Informal document **GRVA-06-08**
6th GRVA, 3-4 March 2020
Agenda item 4

Explanations for the suggested amendments to GRVA-05-05-Rev.1

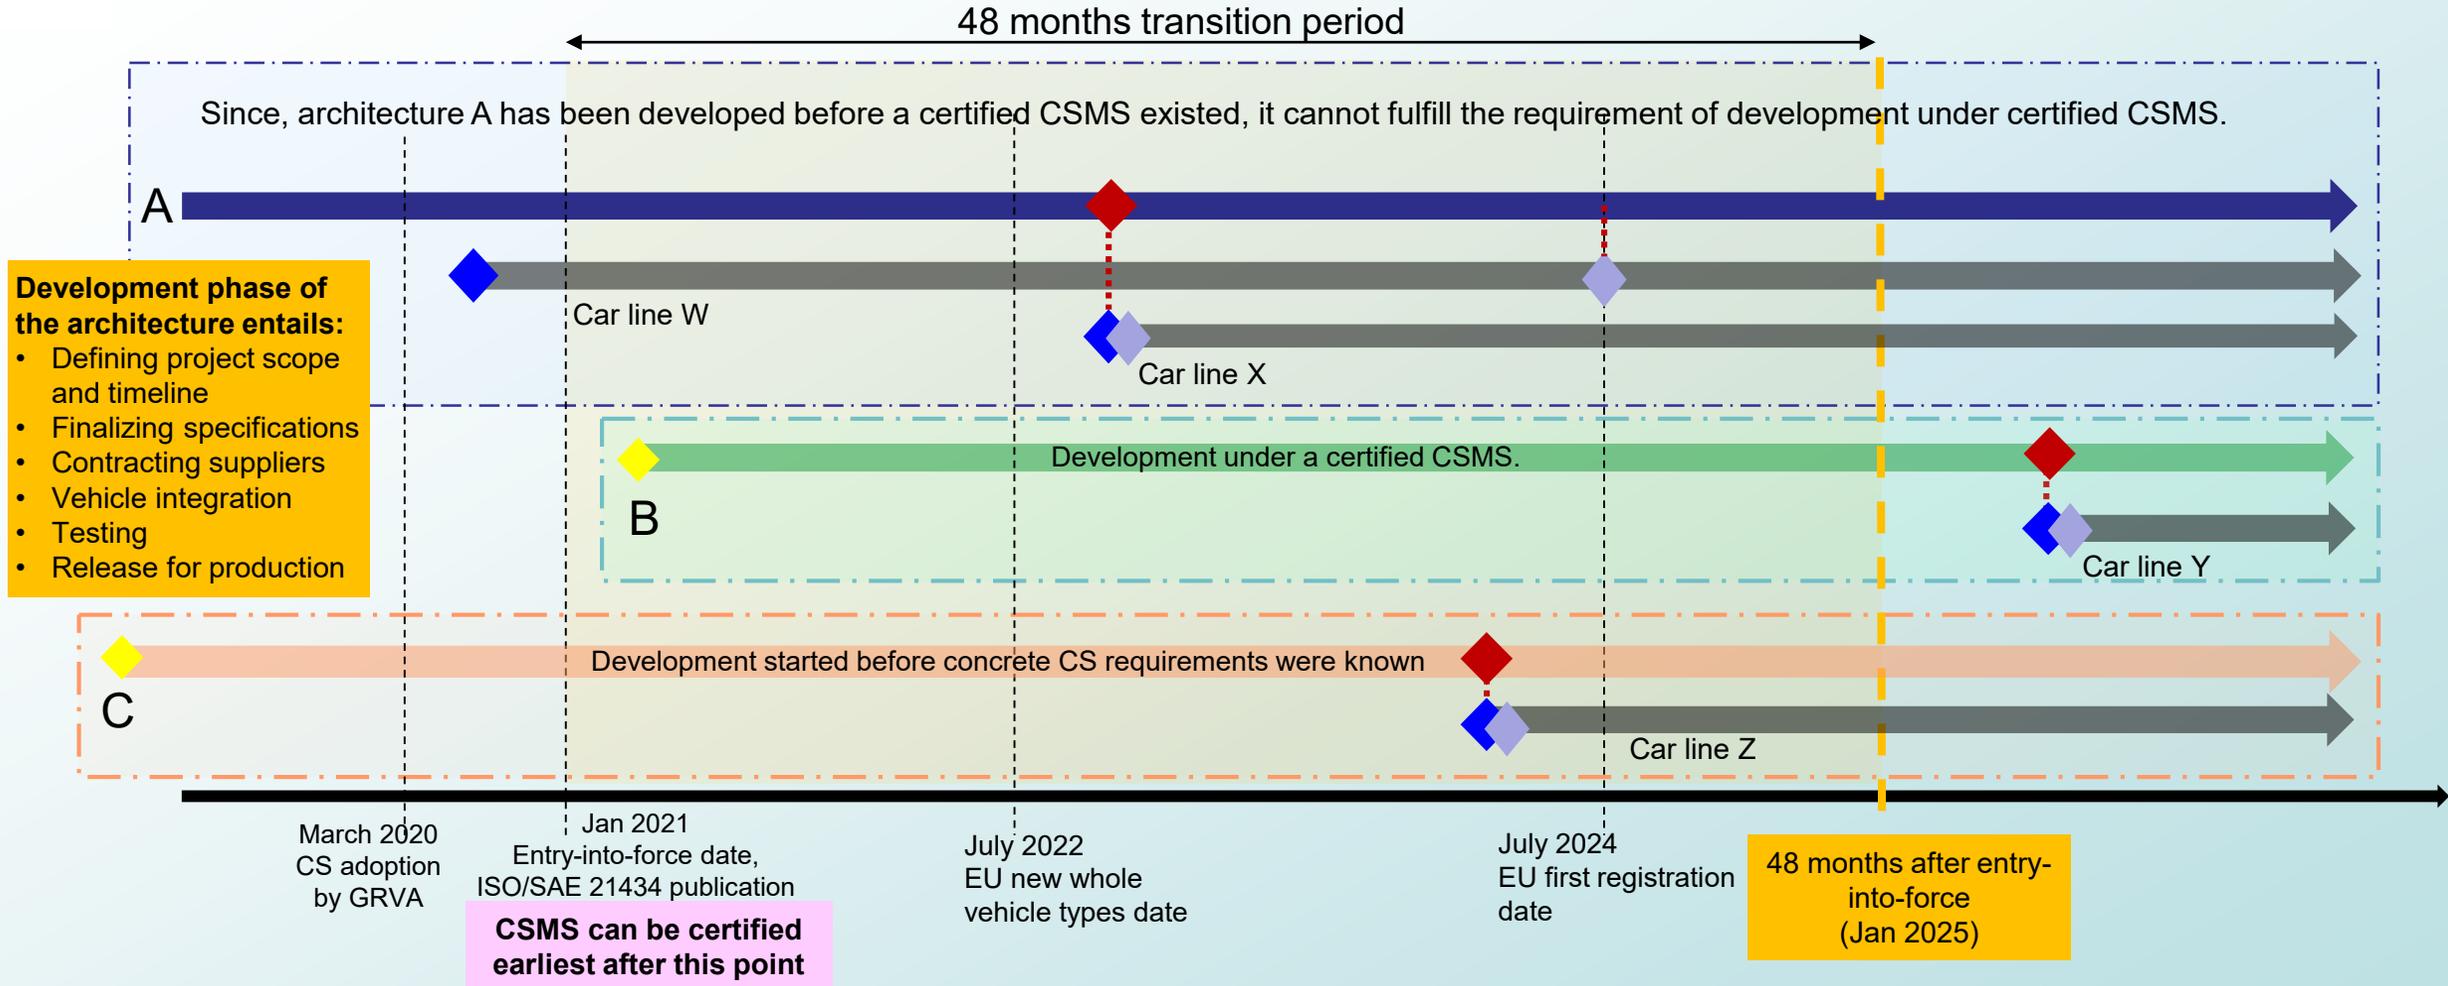
Hard points for existing architectures for formal and technical reasons: 7.3.1. Existing architectures have not been developed under a certified CSMS. 7.3.4. Existing architectures cannot be retroactively brought in compliance with Annex 5.

The 48 months transition period will allow OEMs to incorporate certified CSMS processes (possible only after the regulation comes into force) in the development of their E/E architectures. Also, suppliers need time to incorporate CS processes.

Explanation for 48 months transition time

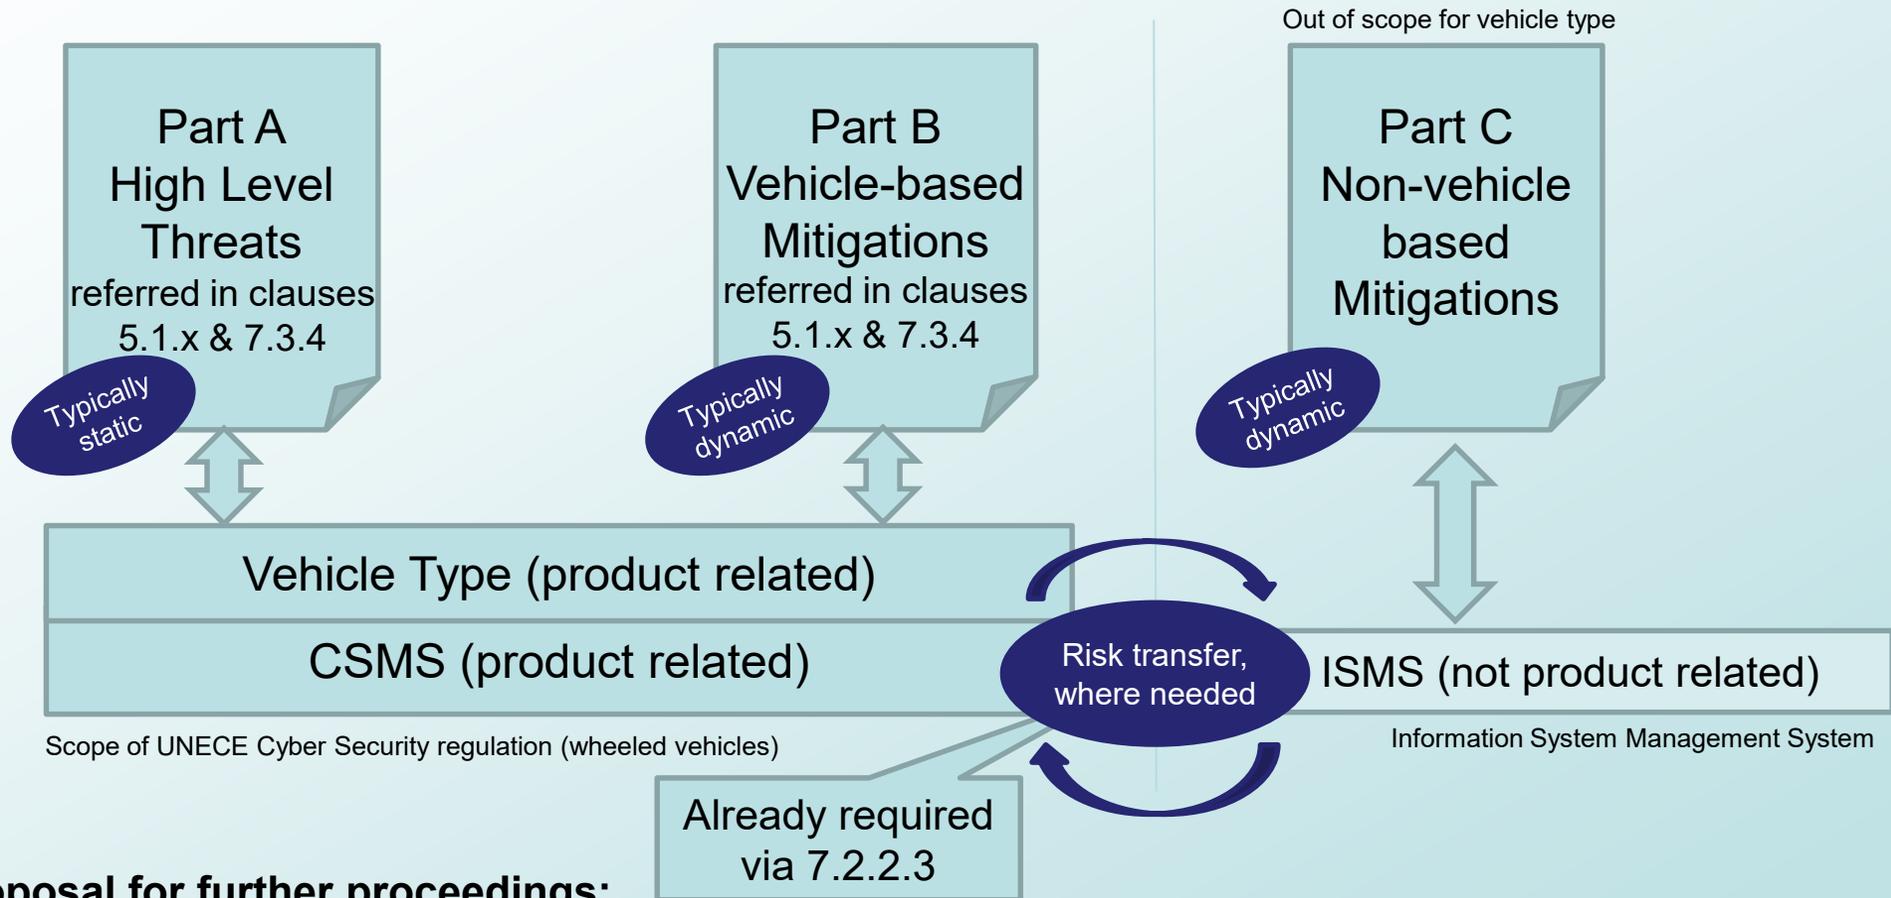
- Manufacturers need to adapt their internal processes
- Review and perform risk assessment for **all existing architectures** and bring them in line with requirements of 7.3.4.
- Update contracts with suppliers. The suppliers in turn need to contact tier-2 suppliers.
- In order to fulfill the supply chain requirement of the regulation, the suppliers need to be certified for cyber security.
- **48 months is representative for the timeframe required for change management of existing architectures not for new developments.**

Architecture A		European WVTA
	Architecture B		System Type approval
	Architecture C		Start of development
	Vehicle types		CS system approval mandatory
